**PLANNING BOARD AGENDA**  
**NOVEMBER 8, 2017 – 7:00 P.M.**

RE: JMC Project 17155  
Easter Seals New York  
97 Old Route 6  
Town of Carmel, NY

On behalf of Easter Seals New York c/o Fedcap Rehabilitation Services, Inc, we are pleased to submit the following revised documents and new documentation to address the Board and staff comments in support of their application for Amended Site Plan Approval for the addition of an outdoor play area and other site modifications:

**LAYOUT PLAN**  
EAST SEALS NEW YORK  
TOWN OF CORNELL, NY 14844

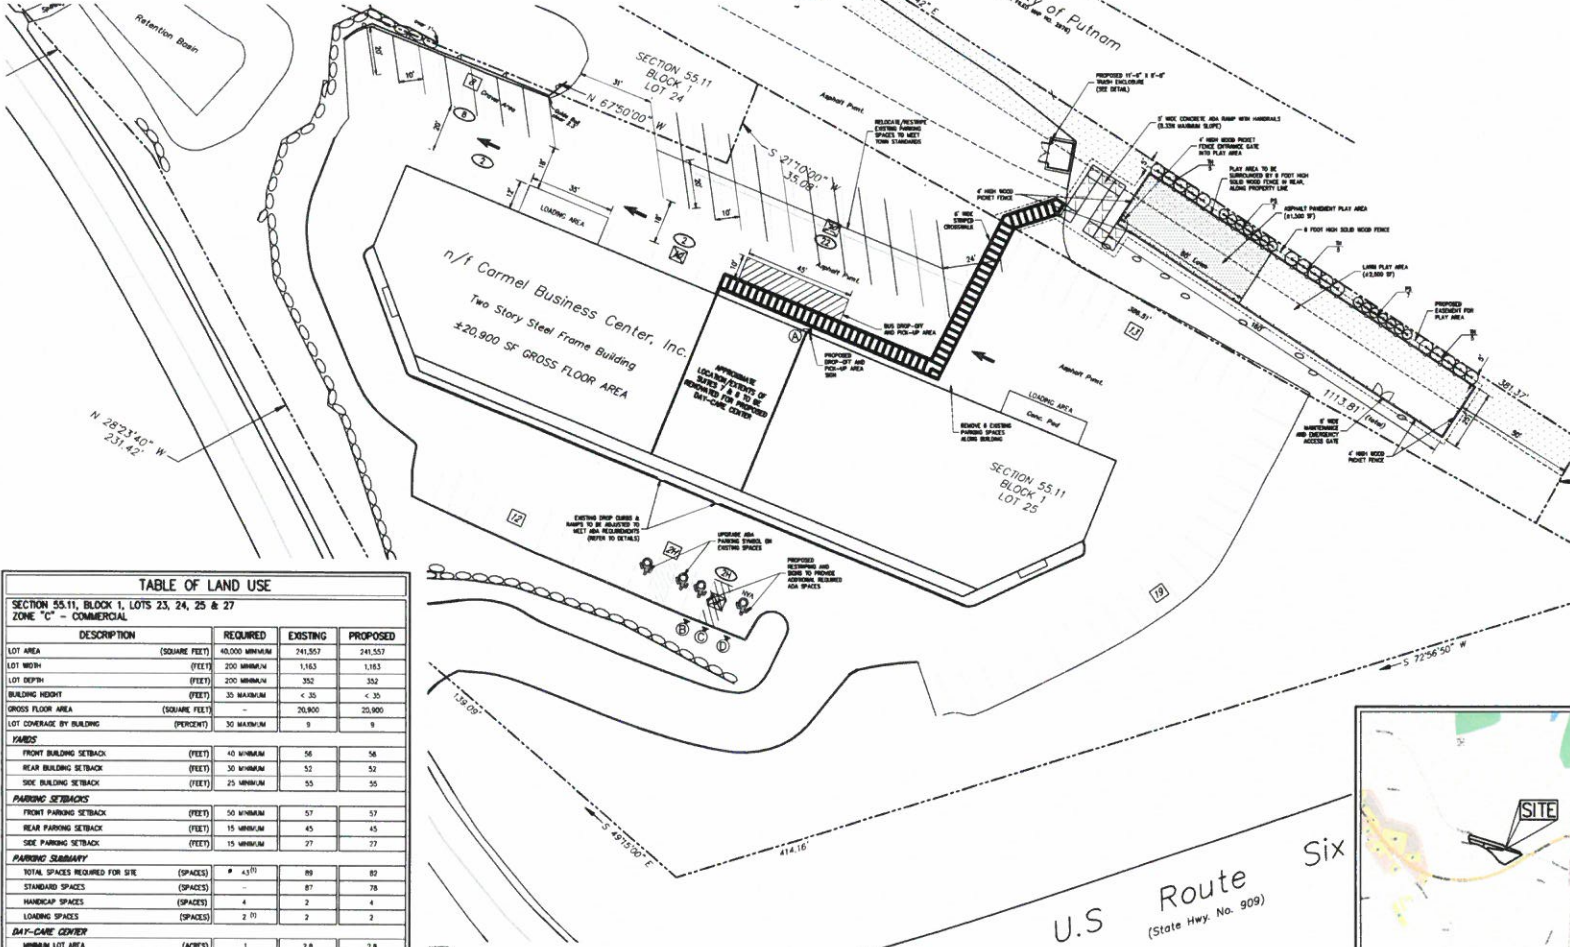
*Provide the parking calculation for the entire site (How did you come up with 43 parking spaces required?).*

*There shall be provided one off-street parking space for each teacher and staff member and one space for every 10 pupils. Parking areas shall be located at least 15 feet from side and rear lot lines and at least 50 feet from the street line. The parking area shall be permanently improved and, if located adjacent to any play area, shall be screened by a fence or hedge at least four feet in height. Pickup and dropoff areas for pupils shall be separate from off-street parking areas.*

- *The facility will employ 10 teachers and support 20 children. 12 off-street parking spaces are required. The applicant has indicated that this parking will be accommodated within the existing parking lot. **This condition is complied with.***
- *The existing parking layout does not comply with the setback standard. No change to this preexisting non-conforming condition is proposed.*
- *The parking area is currently permanently improved and a fence is proposed around the play area. **This condition is complied with.***
- *A separate pick-up and drop off area is provided. **This condition is complied with.***

The required parking calculation is based on the approved Site Plan calculation. A separate calculation is provided for the proposed day care. As demonstrated from the Table of Land Use on the Site Plan, the site meets the requirements for parking.

The Site Plans show modifications to the existing parking layout to comply with the code requirements.

### CONCRETE SIDEWALK/ADA RAMP

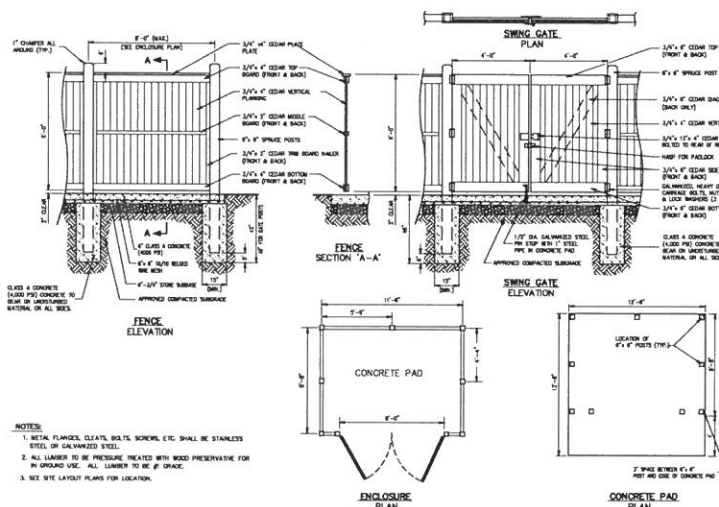
*Show details of ADA compliant ramps in the front of the building.*

*The applicant advised that the surfaces will be improved to meet ADA standards.*

*The drawing should be updated to show the detail of this ramp and any improvements being made.*

Upon inspection by JMC staff, the existing ADA ramps do not fully comply with the ADA regulations. The drawing have been revised to note that improvements are required and a detail has been provided.

### TRASH ENCLOSURE WITH CONCRETE PAD (WOOD)

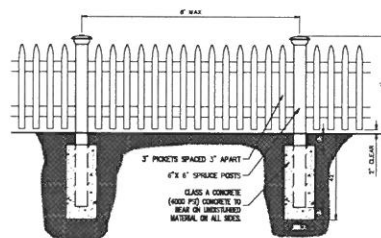
*All accessory structures and features shall be adequately accommodated on the site. Dumpsters shall be indicated on the site plan and shall be enclosed and screened. Storage buildings shall be directly accessible and shall not interfere with circulation patterns or open space areas. All play apparatus shall be installed in accordance with the manufacturer's specifications.*

*Details are required, if applicable.*

We observed two small 3 yard dumpsters sitting on the pavement in the parking area behind the building. The drawings have been revised to show a proposed trash enclosure in the rear parking area and a detail of the enclosure.
